**Exhibit A**

**File No. 230626**

**1<sup>st</sup> Amendment to Detailed Planned Development known as Block 3 – Arena Master Plan (Phase 1)  
1051 & 1047 N Vel R Phillips & 500 West State Street (formerly part of 1001 N. Vel R. Phillips Av.)  
September 18, 2023**

- New CSM configuration:

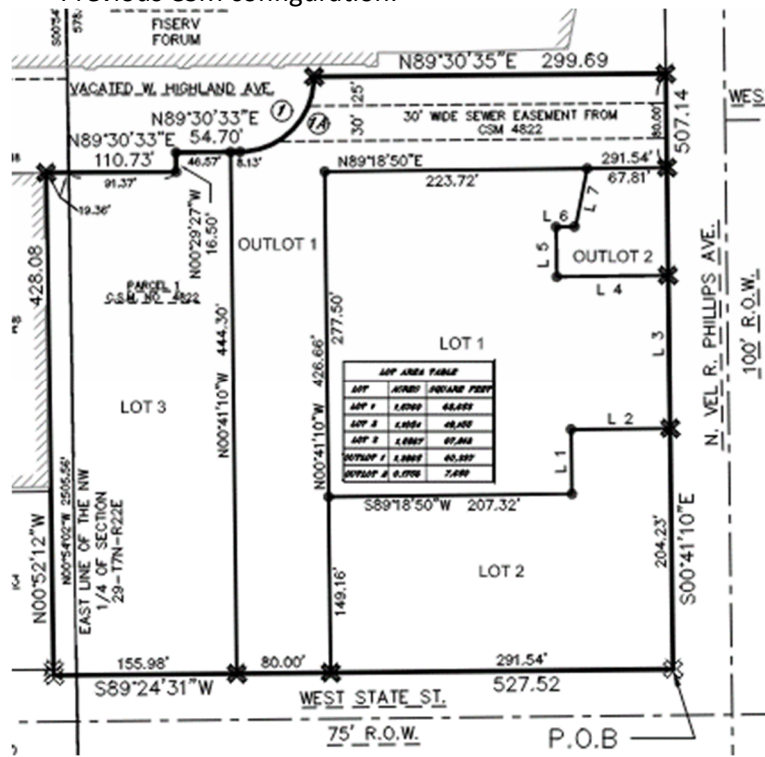
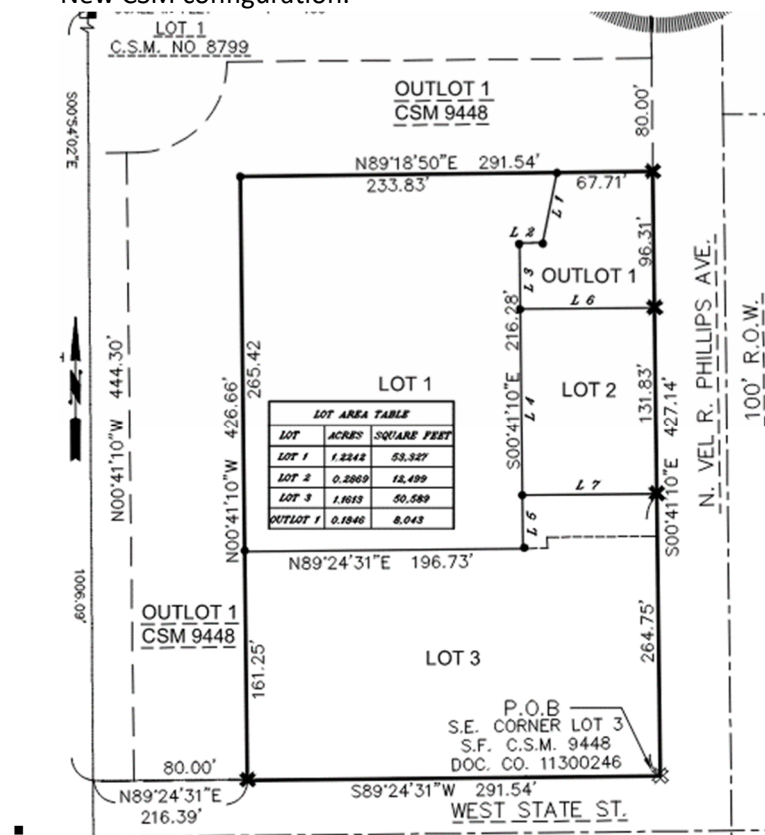
- A new CSM has been submitted to split the Lot 1 (1051 N Vel R Phillips) parcel and create a new lot (to be known as Lot 2) between the music venue and Vel R. Phillips Avenue for future development.

- The music venue parcel (1051 N Vel R Phillips) will continue to be known as Lot 1 of the CSM, and the Outlot (1047 N Vel R Phillips) northeast corner plaza of the site will now be known as Outlot 1.

- Because of the smaller footprint of the music venue, approximately 2,434 square feet of land within the DPD is no longer needed and will be shifted to the south parcel 430 West State Street (Lot 3), which is zoned General Planned Development (GPD; Arena Master Plan).

- The new CSM submitted, in conjunction with this amendment request, created a need to clarify the Lot and Outlot names and addresses as follows for this amendment:

- Lot 1 - 1051 N Vel R Phillips remains as the music venue parcel; remains in the DPD. Approx. 2,434 sf of land from this lot will shift to Lot 3
    - Lot 3 - 430 West State Street (formerly Lot 2) – remains zoned GPD and gets slightly larger

- Lot 2 (future development site)– Requires new address to be assigned (formerly the east portion of Lot 1); remains in DPD
    - Service/Plaza Outlot - 500 West State Street (service drive and north plaza that were formerly labeled as Outlot 1 in the original CSM and DPD exhibits); remains in DPD

- Outlot 1 (east plaza) - 1047 N Vel R Phillips (formerly labeled as Outlot 2 in the original CSM and DPD exhibits); remains in DPD
